Avonlie Solar Farm Modification 1

Disturbance footprint and intersection change
State Significant Development Modification Assessment
(SSD 9031 MOD 1)

Published by the NSW Department of Planning, Industry and Environment

Figure 2 | Proposed modified project layout

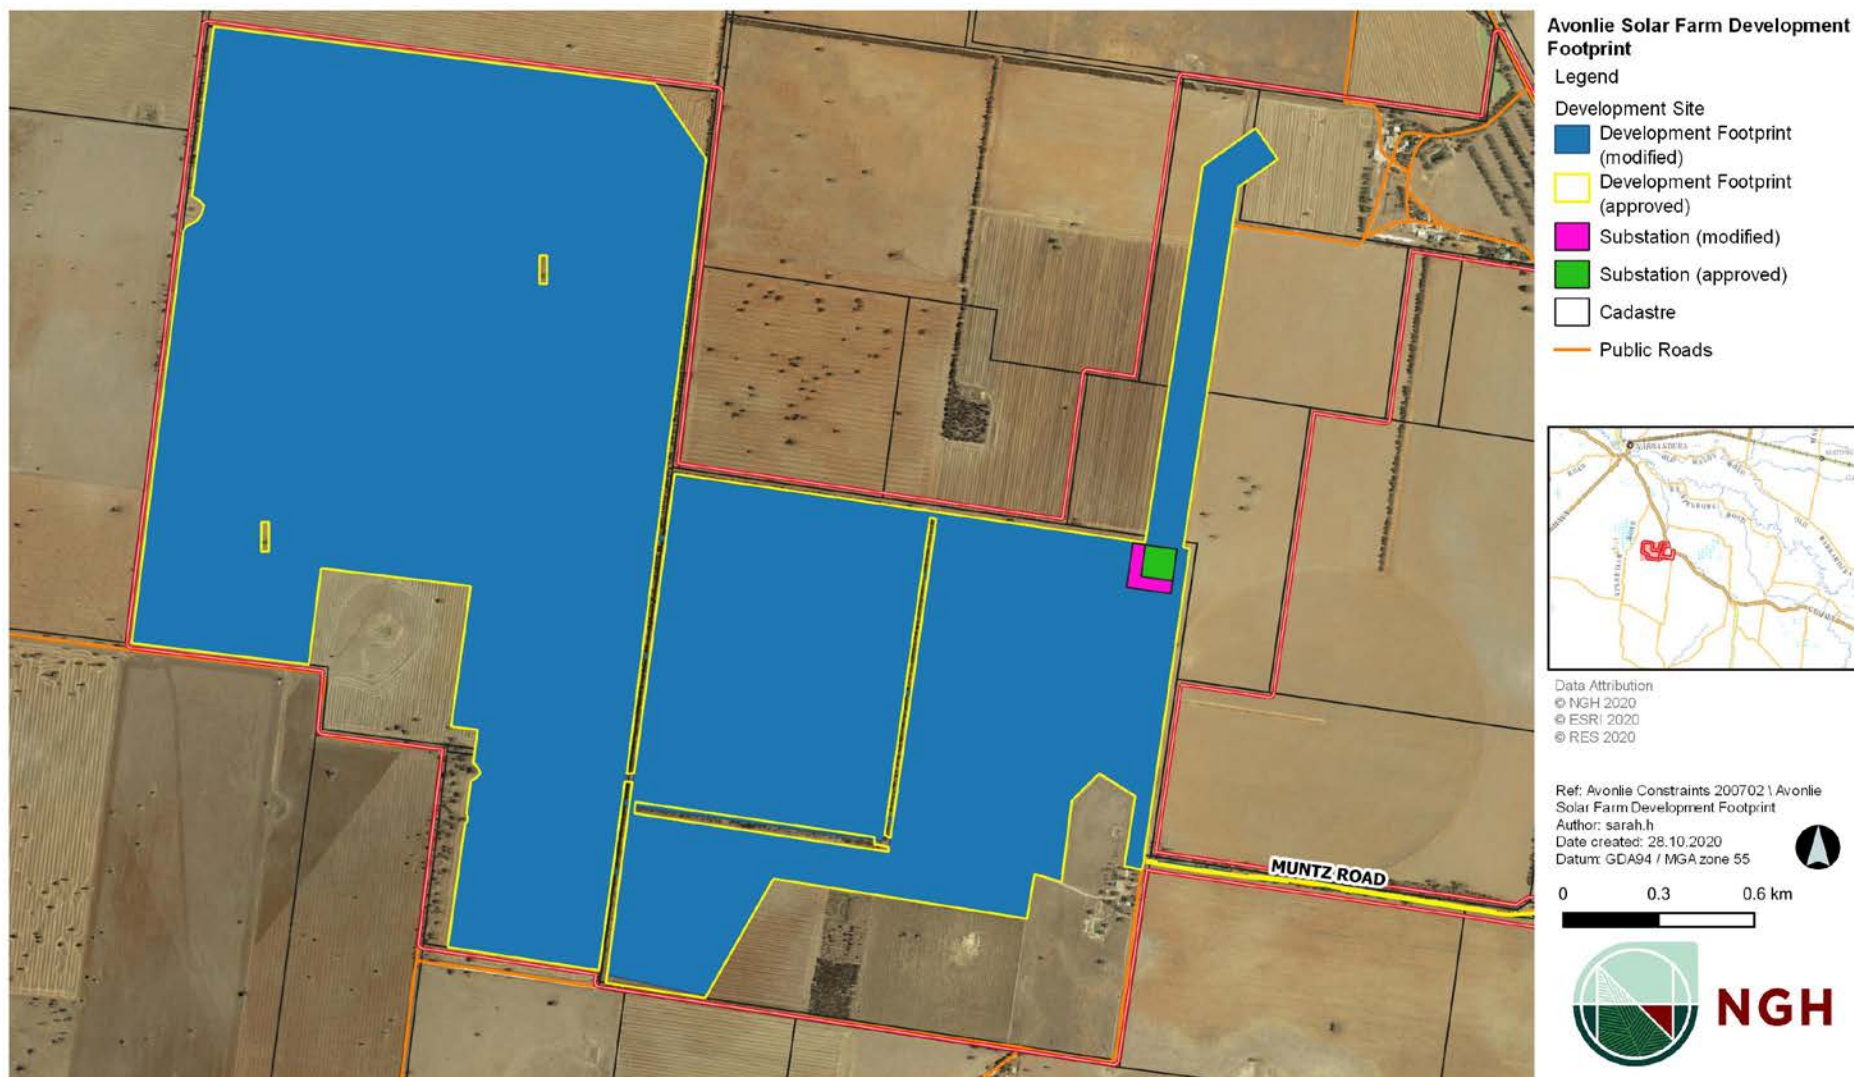
- remove the Basic Left-turn Lane (BAL) treatment from the Sandigo Road and Muntz Road intersection design following consultation with Council's during detailed design and Council's advice that it is not required;
- refine the development footprint at the Sturt Highway / Sandigo Road and Sandigo Road / Muntz Road intersections;
- amend the internal road layout; and
- make minor readjustments to the location of the substation and increase the size of the lot to be subdivided from 1 hectare (ha) to 2 ha following consultation with TransGrid in detailed design to accommodate TransGrid's asset protection zone and safe access requirements.

While the size of the development footprint remains unchanged (i.e. 550 ha), importantly the amended internal road layout/intersection design would result in 0.15 ha less native vegetation clearing.
